RESPONSE TO REQUEST FOR ADDITIONAL INFORMATION

APR1400 Design Certification

Docket No. 52-046

RAI No.: 125-7975
SRP Section: 16 - Technical Specifications
Application Section: TS Section 3.6 and Base
Date of RAI Issue: 08/04/2015

SR 3.6.6.1

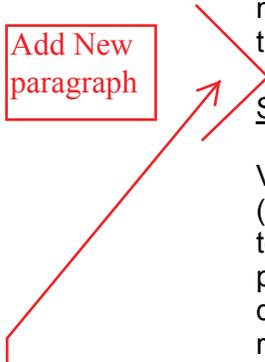
2. On Page B 3.6.1-5, in the discussion of SR 3.6.1.1, the redundant paragraph at the end should be removed.
3. The discussion of SR 3.6.6.1 in the bases does not include the basis for the 31-day frequency. The applicant is requested to provide the basis for the stated frequency.

3. The basis for the 31-day frequency in SR 3.6.6.1 will be added consistent with the STS as indicated in Attachment 3.
4. The closure of a containment penetration during reduced inventory operations requires different design criteria than during refueling operations. Since the explained term of equivalent in LCO 3.9.3 for refueling operations may not be adequate for reduced inventory operations, that alternative for isolation will be deleted from Technical Specification 3.6.7 as indicated in Attachment 4. Unlike the Bases for LCO 3.9.3, the Bases for 3.6.7 does not include clarification for the term 'equivalent' and, therefore, no change to the Bases for 3.6.7 is necessary.

Add New
paragraph

The 31 day Frequency is based on engineering judgment, is consistent with the procedural controls governing valve operation, and ensures correct valve positions.
